**DESIGN
FOR
TEMPORARY BRIDGE**

HANCOCK ER BRF 0174
(16)
HANCOCK, VERMONT

Vermont Agency of Transportation
RECEIVED
HANCOCK ER BRF 0174(16) Temporary Bridge Plans, Permit 1-20-2012.pdf
CK'D BY WDL OK'D BY JTS
March 19, 2013
RESUBMIT YES Rejected
BY KMH DATE 03/26/13

DETOUR NOTES

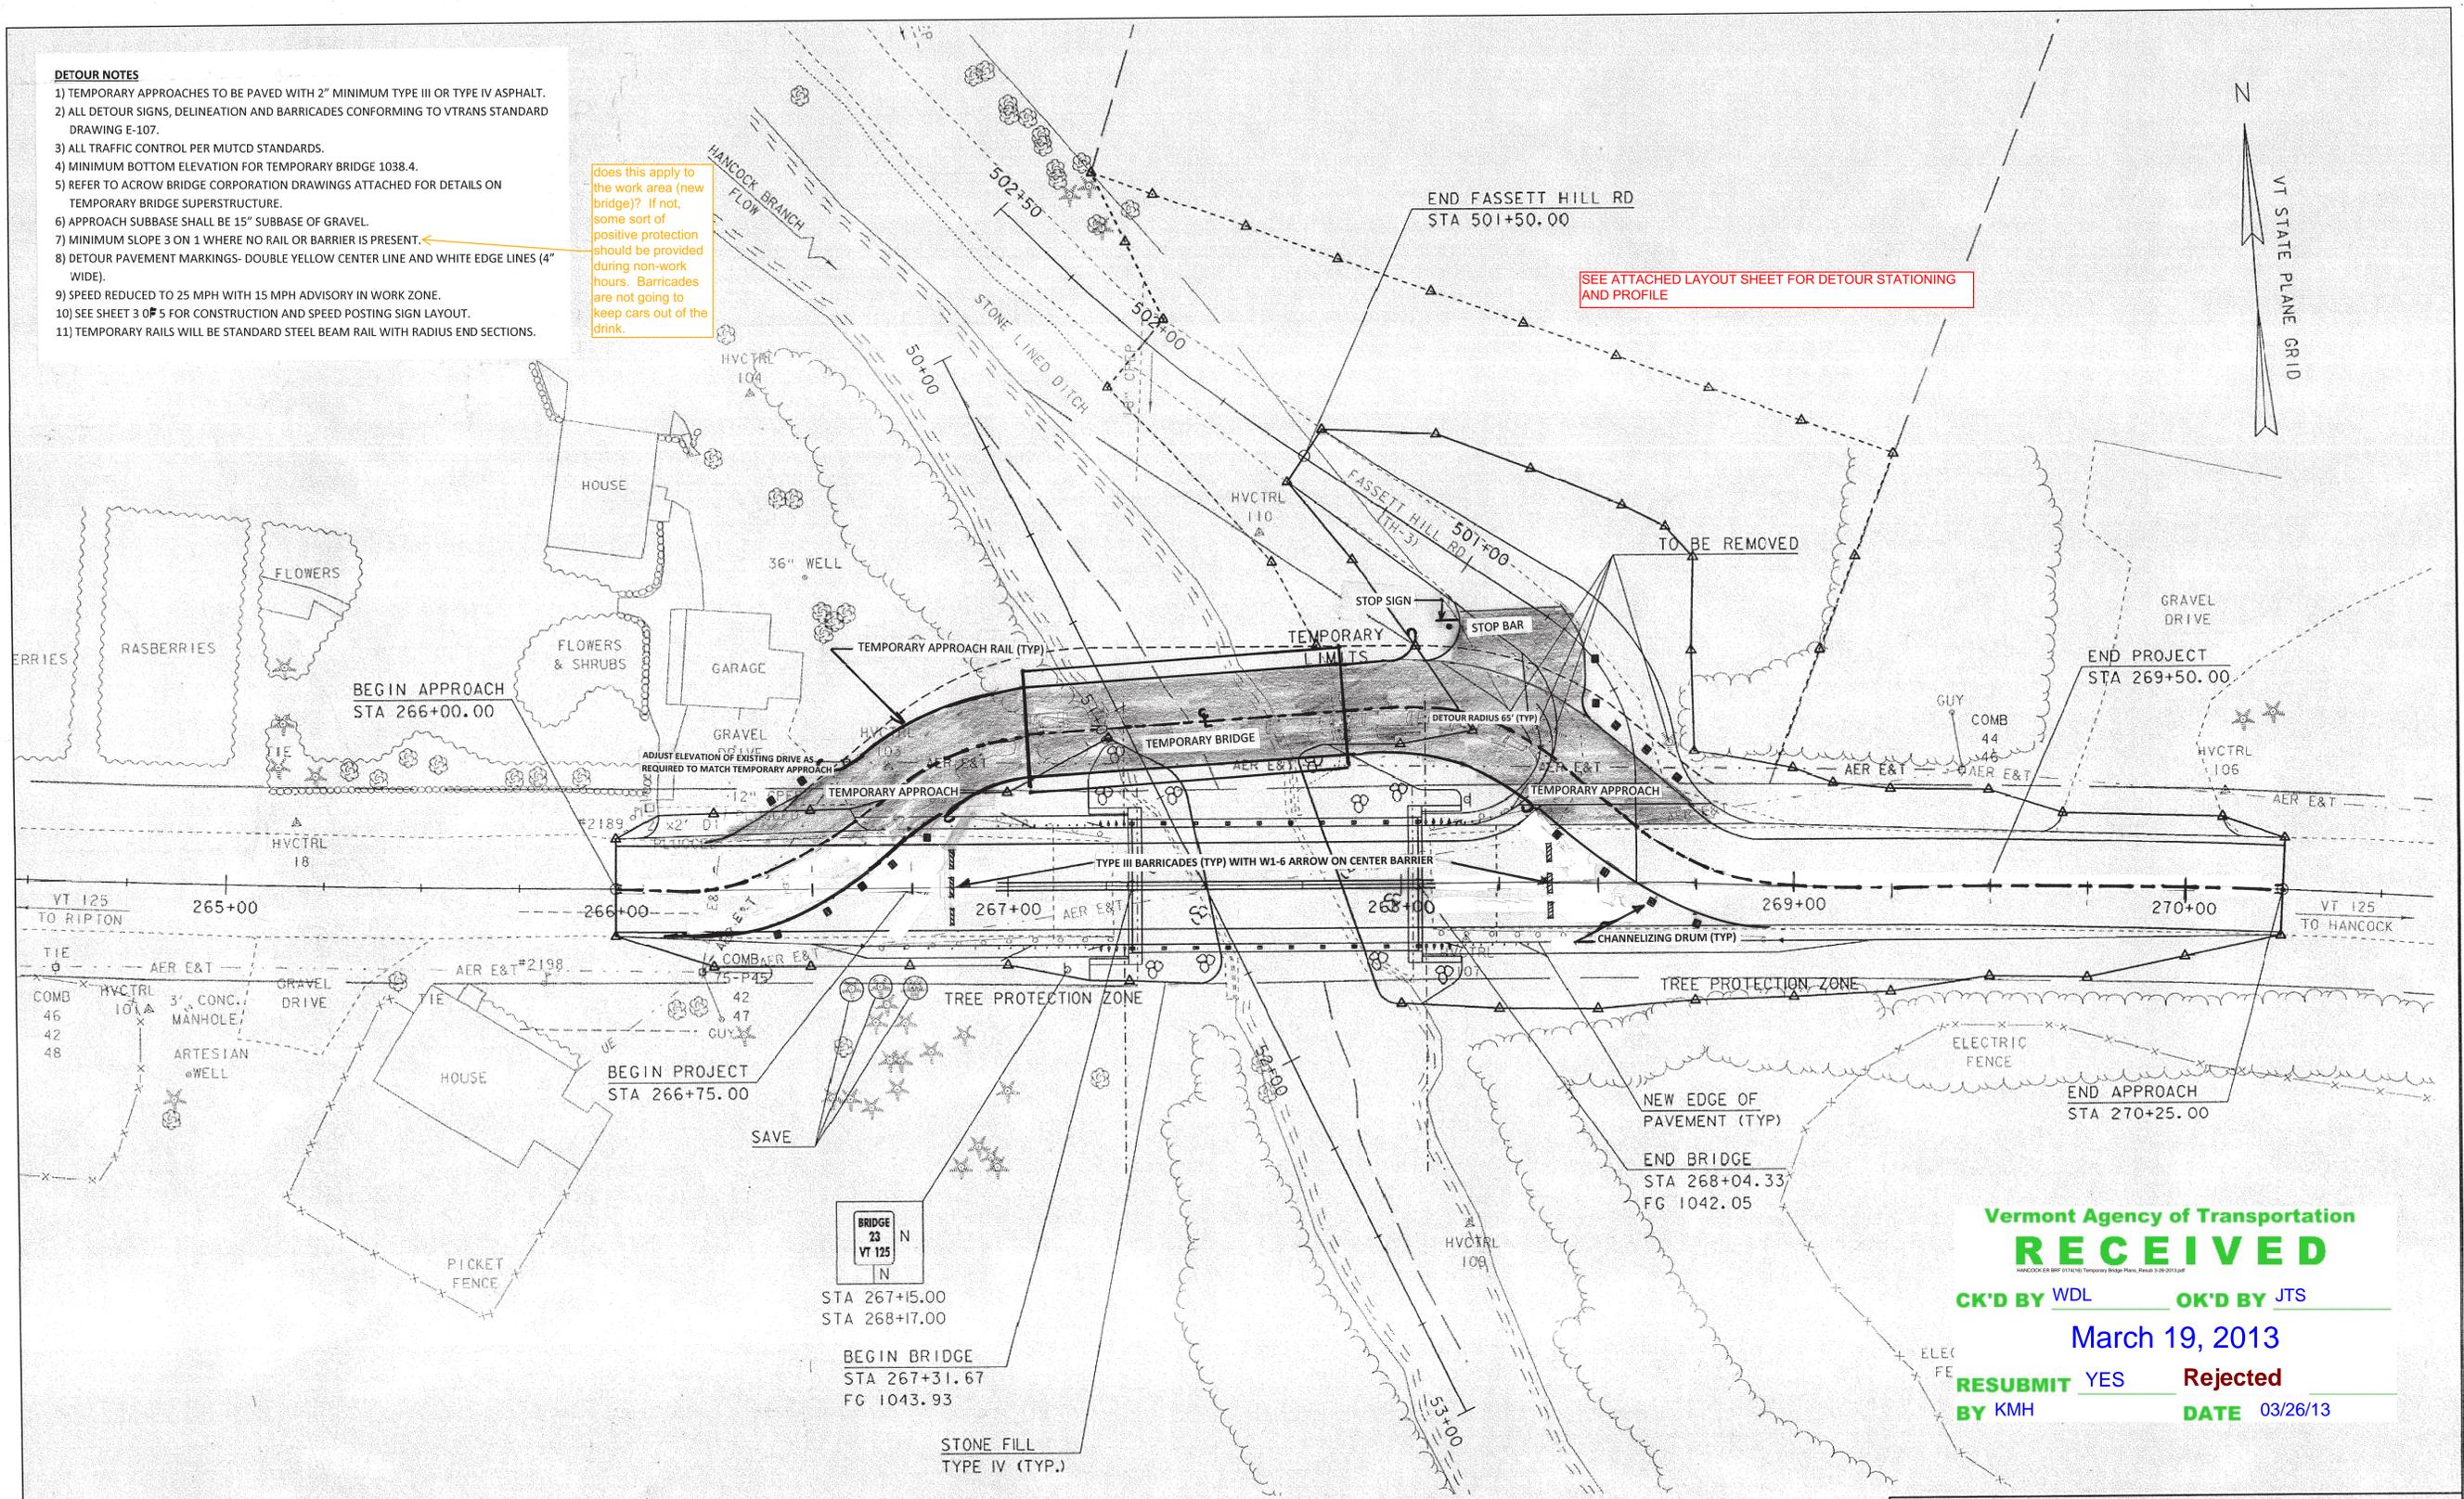
does this apply to the work area (new bridge)? If not, some sort of positive protection should be provided during non-work hours. Barricades are not going to keep cars out of the drink.

DETOUR LAYOUT PLAN

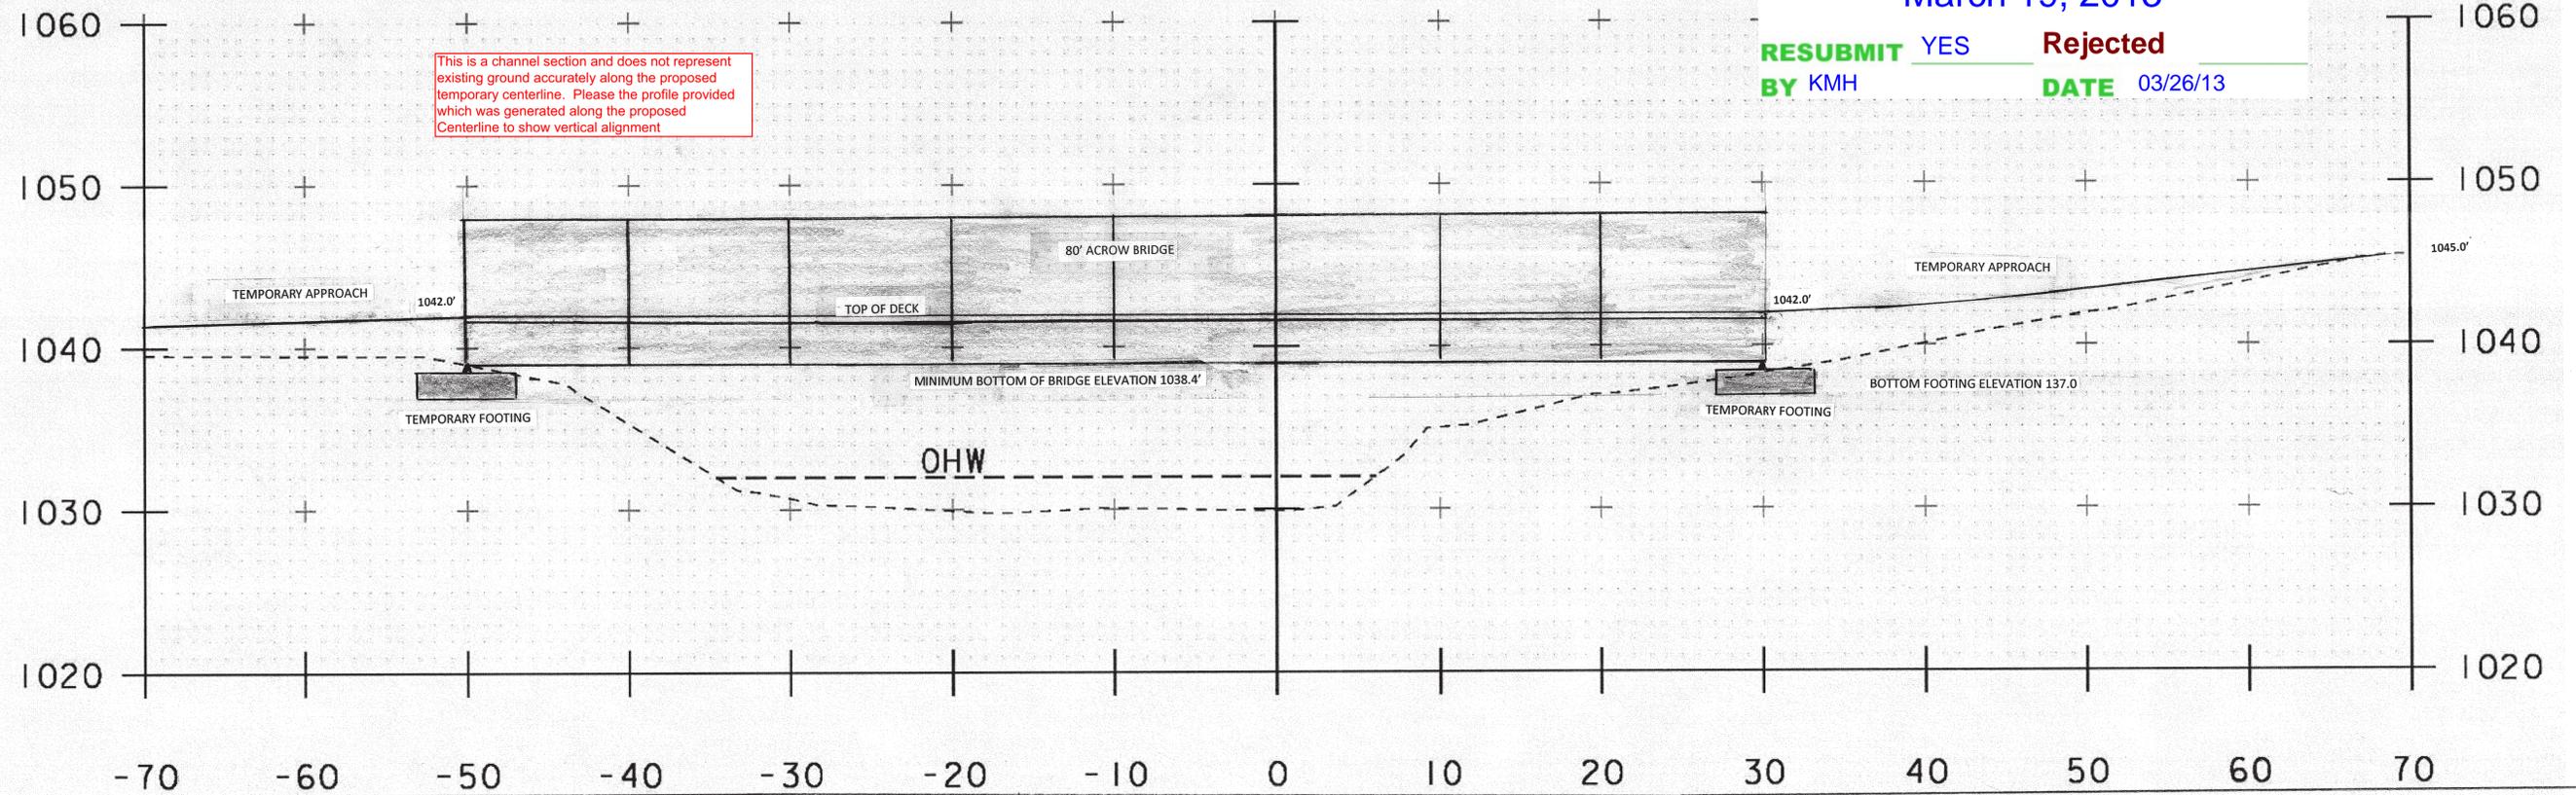
How is this going to work? Show an elevation view of plywood retaining fill along the width of the bridge. Should be part of design calculations as well and include LL surcharge from Roadway.

Connection of plywood to footing

submit abutment design calculations stamped by a PE per section 528.04.

Bearing provided by Acrow Panel Bridge?

BACKWALL DETAIL

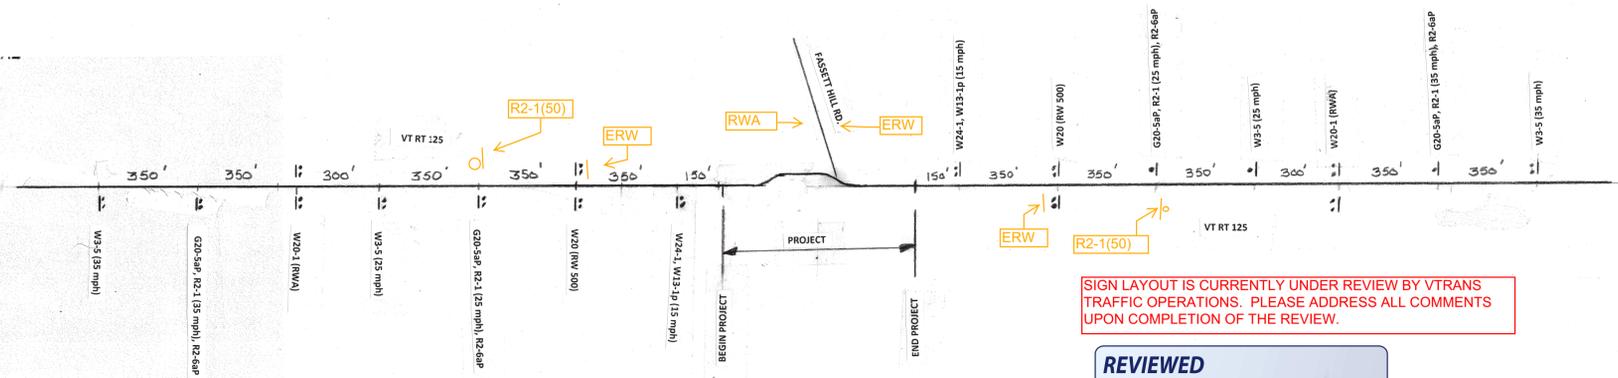
SIGN LAYOUT IS CURRENTLY UNDER REVIEW BY VTRANS TRAFFIC OPERATIONS. PLEASE ADDRESS ALL COMMENTS UPON COMPLETION OF THE REVIEW.

DETOUR PROFILE
 ALONG CENTER LINE

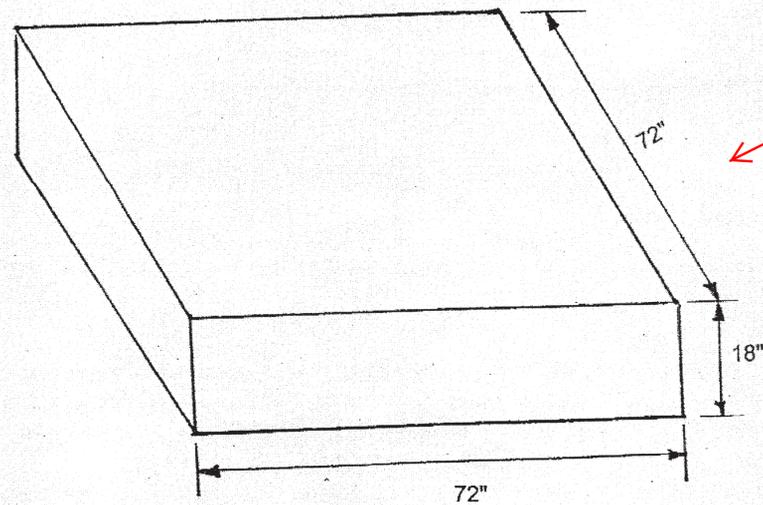
Need to see design for this.

Footing Location

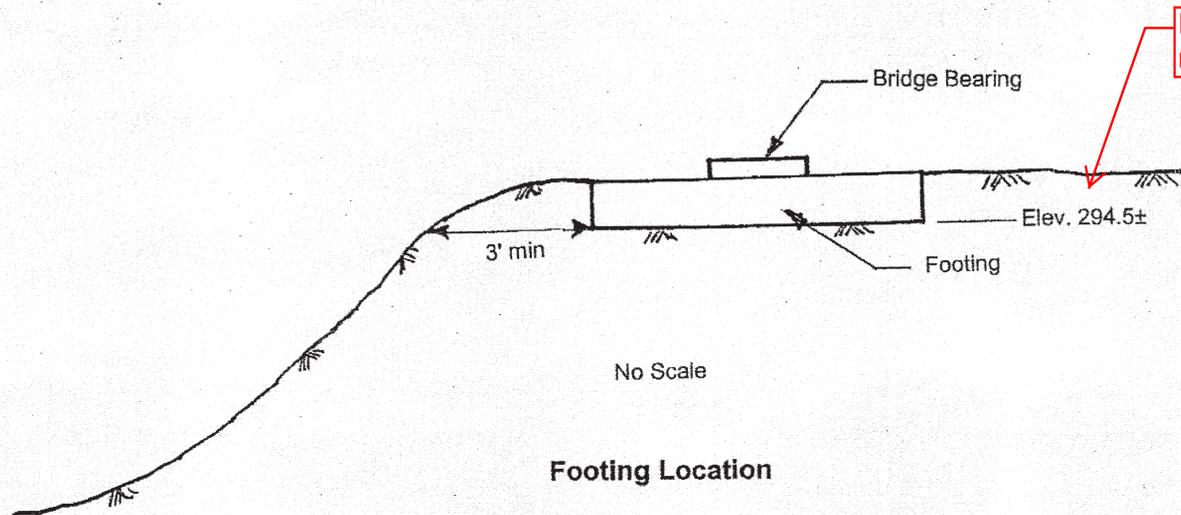
Elevation doesn't make sense
